BEST BEST & KRIEGER
ATTORNEYS AT LAW

September 27, 2007

Re: Comments on July 2007 Revised Draft Environmental Impact Report for Consideration of Modifications to the United States Bureau of Reclamation's Water Right Permits 11308 and 11310 (Applications 11331 and 11332)

Figure 1
Cachuma Project Incremental Shortages Compared to Alternative 1
in Critical Drought Period, 1949 through 1951

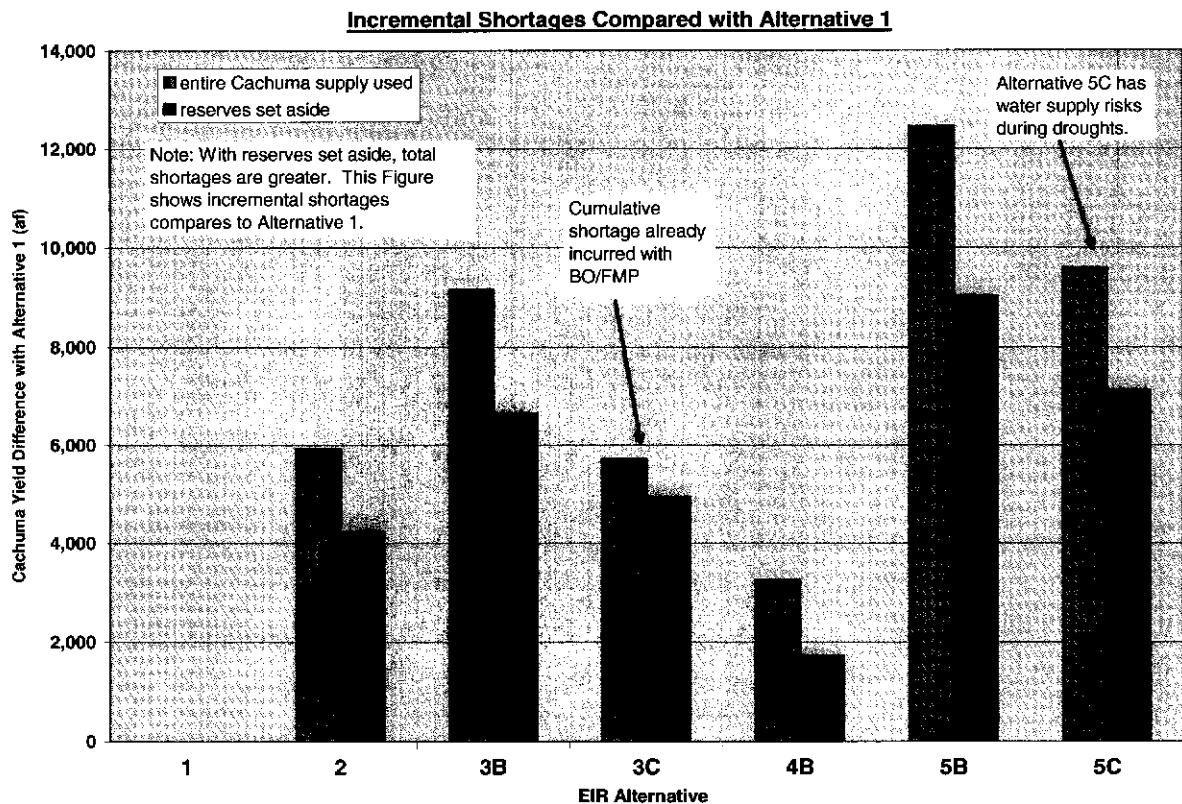
• Tables 12 and 13 below compare Cachuma Project water shortages during the critical drought period, with and without reserves set aside, to shortages under Alternative 1 – existing water rights under WR Order 89-18 (2003 DEIR). As Tables 12 and 13 both indicate, the Member Units have already incurred significant water supply reductions during critical drought periods by operating consistently with Alternative 3C. These operating conditions were developed over the period 1994 to 2000 as a result of meetings between and among Reclamation, the Member Units, NMFS, various downstream interests, and other parties, and resulted in NMFS’ steelhead Biological Opinion and the Lower Santa Ynez River Fish Management Plan. Tables 12 and 13 below show that the Cachuma Project water supply resulting from Alternative 3C is about a 10-11 percent reduction from the target yield of 25,714 acre-feet compared with Alternative 1. Figure 1 shows the incremental Cachuma Project shortages compared with Alternative 1, with the largest incremental shortages occurring under Alternatives 5B and 5C. It should be noted that while relative differences in Cachuma shortages are greater in the SYRHM when the entire Cachuma supply is used, the absolute shortages in the SYRHM are much greater with reserves set aside.

Figure 2
Frequency of Net Gain/Loss between Bradbury Dam and Solvang Bridge
April through September, When 1.5 cfs Target Flow at Solvang Bridge is in Effect

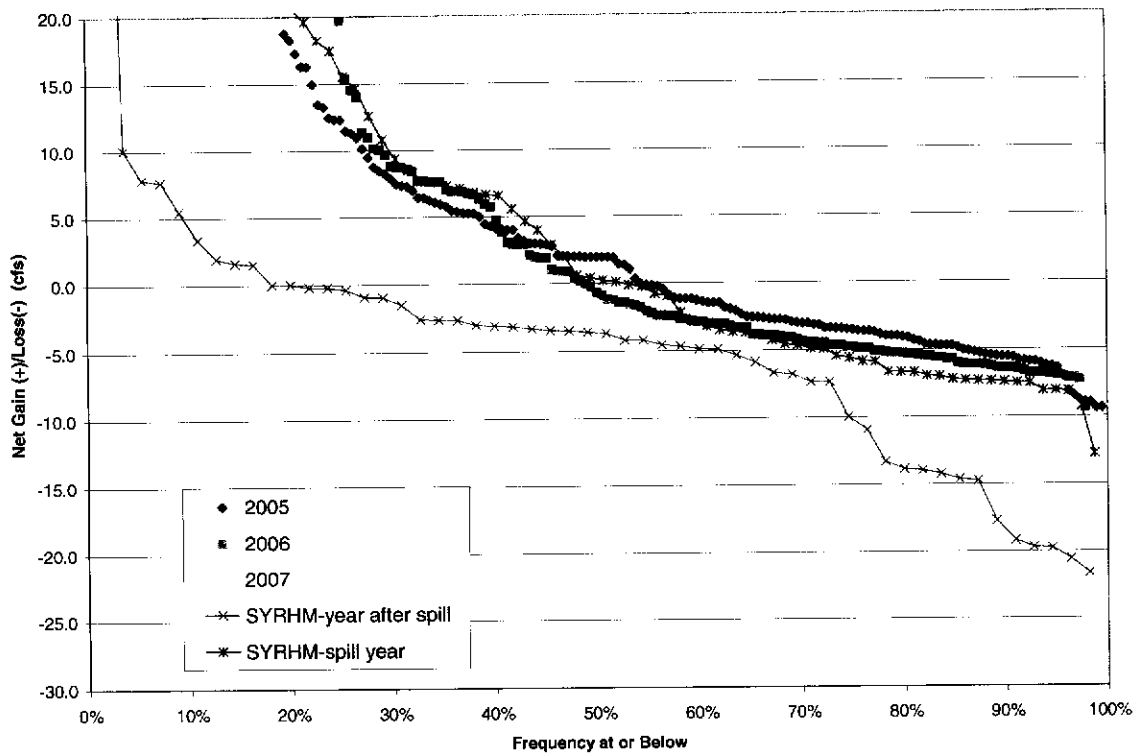
Recent operations for releases for fish indicate that 1.5 cfs at Alisal bridge in itself poses a risk to Cachuma Project water supplies in certain years such as 2007. Under the BO and FMP, long-term operations (Alternative 3C) in a spill year greater than 20,000 cfs and in the year after a spill, provide that the target flow at Alisal bridge is 1.5 cfs. In fact, BO/FMP long-term operations began after the spill in 2005. 2006 was also a spill year, and 2007 is the year after a spill. However, 2007 also happens to be the driest year on record at Cachuma Reservoir in the year after a spill. The SYRHM is based on years 1918-1993. The consequence is that much *more* water had to be released than expected under the SYRHM as shown in Figure 2. Sensitivity analyses regarding losses from Cachuma to Solvang bridge and the target flows at Solvang bridge are definitely needed, particularly for an analysis of the reservoir releases contemplated by Alternatives 5B and 5C, for which the SYRHM has not been calibrated.

Figure 3
Excerpt from USGS Water Supply Paper 1366
Ground-water Level Decline near Carpinteria and Goleta (1940-1951)

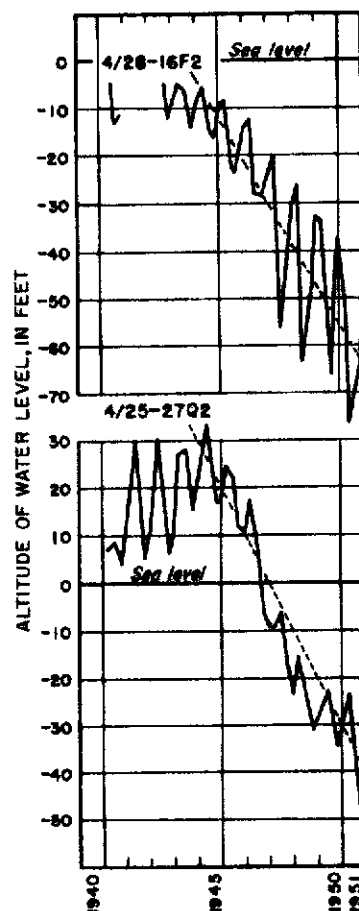
- Potential mitigation of the increase in Cachuma Project shortages caused by the DEIR's alternatives through increased ground-water pumping also requires a more comprehensive review of impacts. For example, in "Water Resources of Southern California with Special Reference to the Drought of 1944-51" (USGS, 1957), the ground-water tables near the Member Units showed considerable decline as illustrated below in Figure 3. The indirect environmental impacts from ground-water pumping during droughts, such as possible sea water intrusion, requires more discussion than is provided in the 2007 DEIR. Currently, the document provides no information or evaluation of local groundwater rights, overall short- and long-term supplies compared to local demand, or the likelihood of those additional supplies proving available in light of legal, technical or other limitations. (2007 DEIR, p. 4-30.) Instead, the analysis simply assumes that significant amounts of groundwater will be reliably and legally available to the Member Units, contrary to the requirements of *Vineyard Area Citizens for Responsible Growth v. City of Rancho Cordova, supra*, 40 Cal.4th 412. (See, e.g., 2007 DEIR, Table 4-25b; Appendix F, Tables 19A-B.) This inadequate analysis results in a gross understatement of water supply impacts to the Member Units.

Figure 1
Comparison of minimum monthly flows for Alternative 3B and 3C and 5B and 5C during the fry rearing period when Alternative 5B and 5C receive a score of 5³

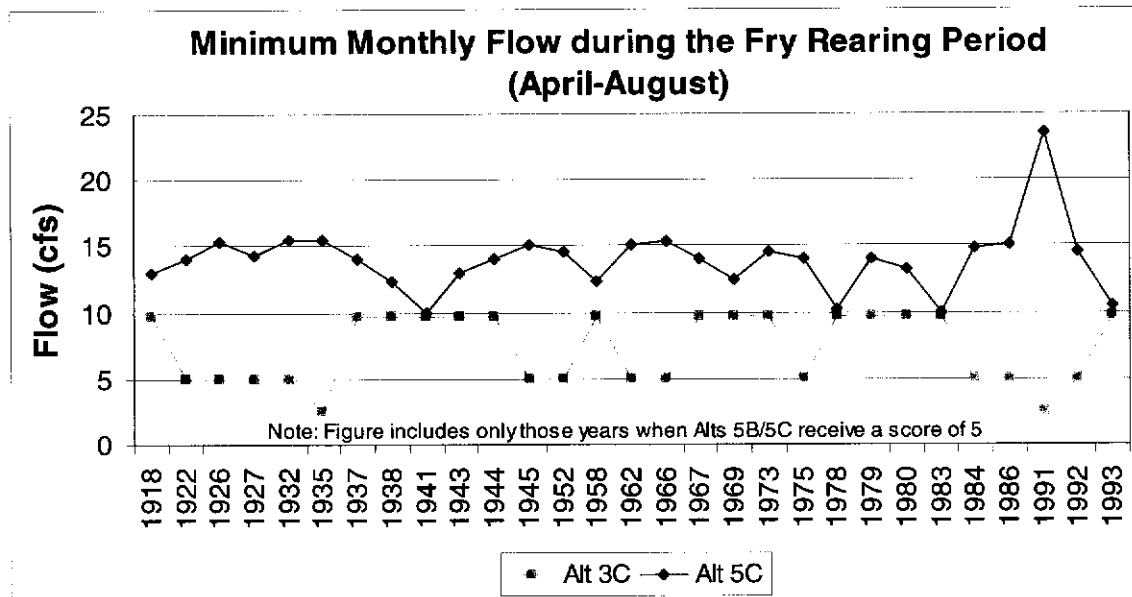
First, the DEIR should note that, while Alternatives 5B and 5C result in an increased frequency of years receiving a score of 5 for fry rearing, all of the alternatives have almost the same number of years receiving scores of 4 or 5, indicating that habitat values are high. During the fry rearing period in years when fry habitat receives a score of 5 under Alternatives 5B or 5C, these alternatives provide an average of 6 cfs more flow than Alternatives 3B and 3C. (See Figure 1 below.) This difference in flow is very significant to the Member Units, but results in only a minor change in habitat for the steelhead. Based on the top-width vs. flow information presented in the Habitat Analysis (SYRTAC 1999a), the difference in top width at flows of 5 and 15 cfs (the range of increase in flows under Alternatives 5B/5C as compared to Alternatives 3B/3C) would range from 4 to 9 feet. (See Figure 2 and Table 1 below.) These changes correspond to an increase in top width of only 6 to 9 percent depending on habitat type. Thus, the increased amount of habitat provided under Alternatives 5B and 5C relative to that under Alternatives 3B and 3C would be small. This small increase in habitat, in spite of relatively large increases in flow occurs because the 10 to 20 cfs summer flows required by Alternatives 5B and 5C, falls far above the breakpoint of the top width vs. flow function. As shown in Table 1 and Figure 2 (replicated from SYRTAC 2000b), top width increases most rapidly as flows increase from 0 to 5 cfs. As flows increase above 5 cfs, the rate at which top width increases drops substantially. Thus, increasing habitat substantially above this breakpoint comes at a much higher water cost.

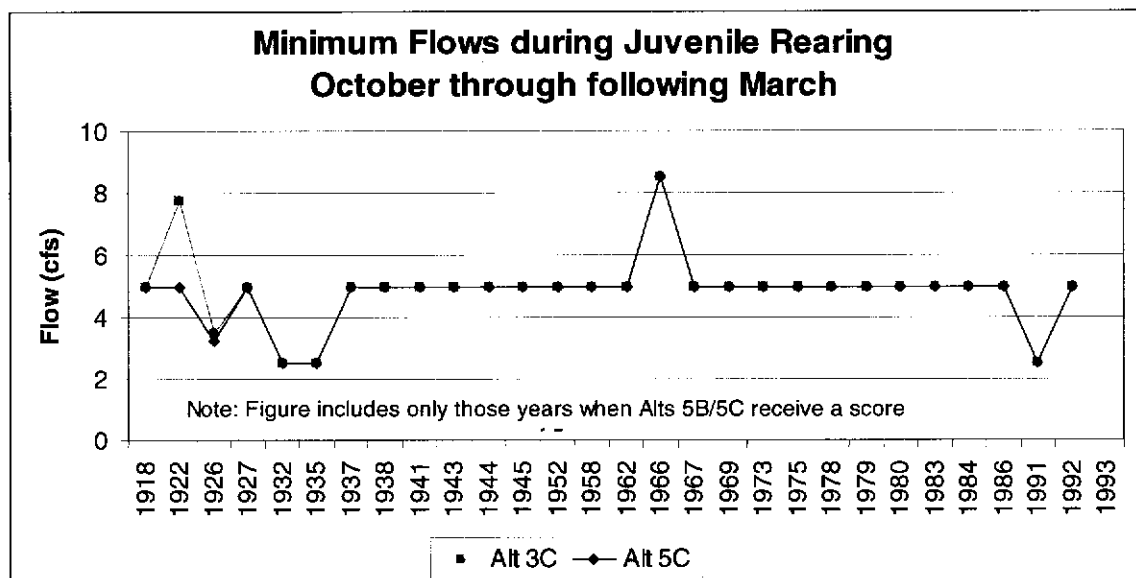
Second, monitoring data show that the additional 10 to 15 cfs minimum summer rearing flows provided under Alternatives 5B and 5C will not improve *other* aspects of habitat that may limit the production of steelhead/rainbow trout even if the volume of fry rearing habitat is increased. For example, data collected by the SYRTAC and presented at the State Board Phase II hearings show that even flows of 50 cfs do not reduce water temperatures in the Highway 154 reach. (See discussion and Figure 3 below.) Thus, Alternatives 5B and 5C do not provide any temperature benefit to steelhead/rainbow trout.

Figure 3
Temperature vs. Flow just downstream of the Highway 154 Reach
 (Note: "Average" represents Average Water Temperature (degrees Celsius))

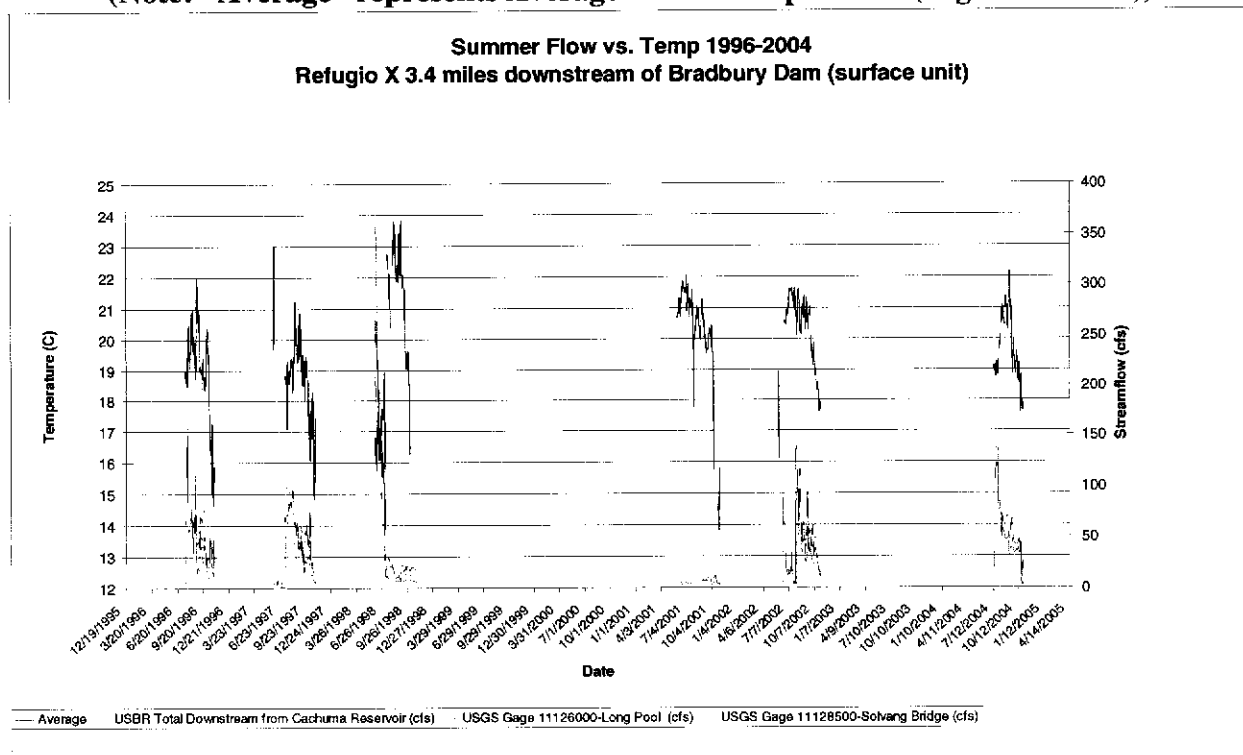
- Page 4-70. The Member Units agree that water temperature may be a limiting factor for steelhead/rainbow trout in the Santa Ynez River, but water temperatures are unrelated to changes in flow, within the range of base flows considered by the alternatives set forth in the DEIR. The results of flow models prepared for the Contract Renewal EIS/EIR demonstrated that beyond 4.4 miles downstream of Bradbury Dam, temperature is not affected by streamflow at the flow levels considered for rearing releases or even at substantially higher flows. (Woodward Clyde Consultants, et al., 1995; as cited in the Biological Assessment (Reclamation, 1999).) These findings were supported by monitoring data from the SYRTAC fish monitoring program,⁴ which show that increased flows of 50 cfs or more did not decrease temperatures relative to those occurring under base flow. (See Figure 3 below.)
